**State of Alaska
Department of Fish and Game
Sportfish Division**

**Nomination Form
Anadromous Waters Catalog**

Anadromous Waters Catalog Number of Water Body 221-60-11450

Name of Water Body *Crooked Creek USGS Name Local Name

Dom # 25-863

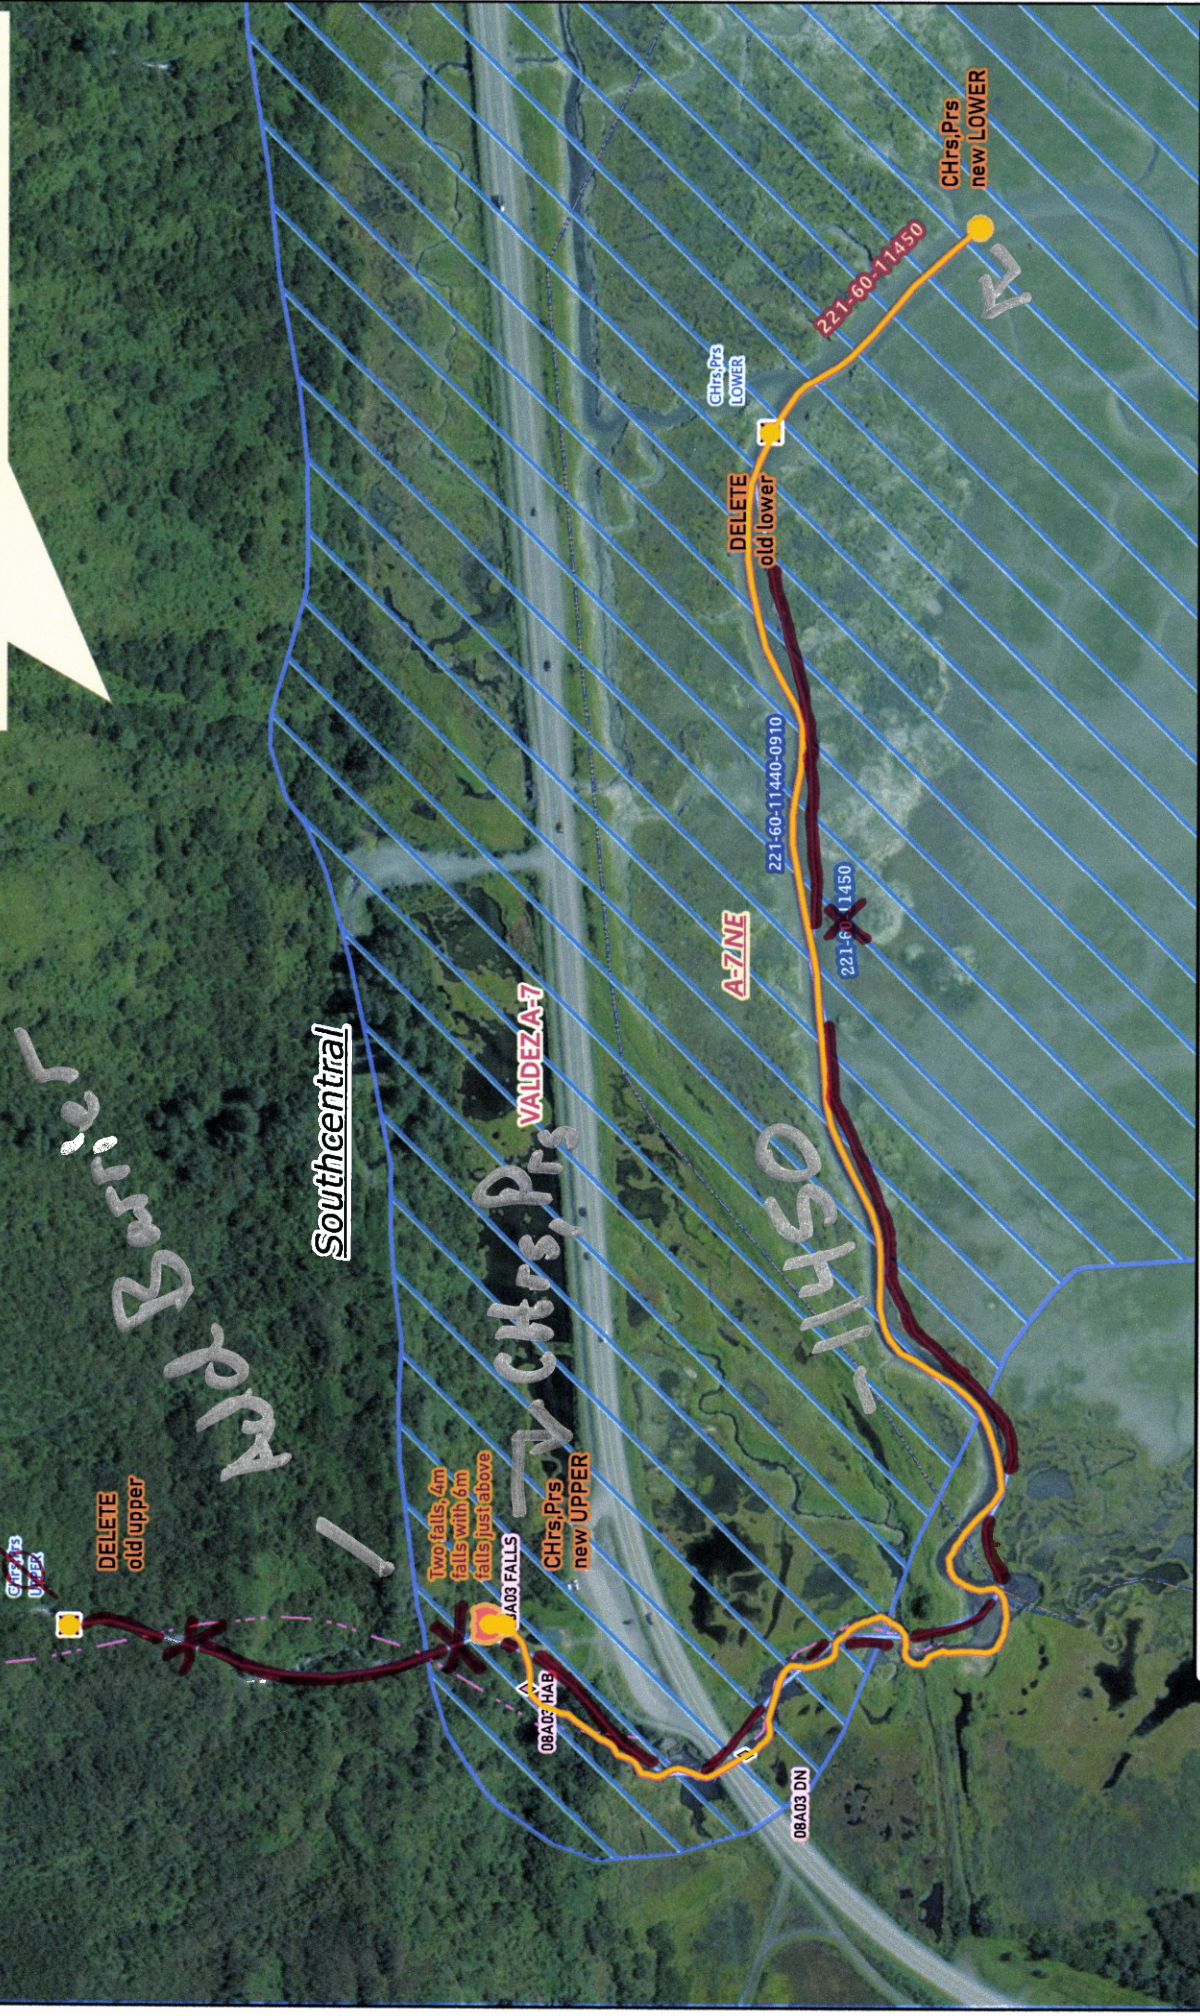
-CHANGE name of existing AWC Stream #221-60-11450 to local name "Crooked Creek".
 -Update/ADJUST hydrography of existing AWC Stream #221-60-11450 "Crooked Creek".
 -SHORTEN current upper extent of existing AWC Stream #221-60-11450 "Crooked Creek".
 -ADD BARRIER above new upper extent of existing AWC Stream #221-60-11450 "Crooked Creek".
 + Please update using most recent_GDB with line, point, lake, polygon and barrier features located in O:\DS\FR6\AWC\Draft2026\GIS\DATA\AWC2026_Wking_V1_7_Apr\2025.gdb
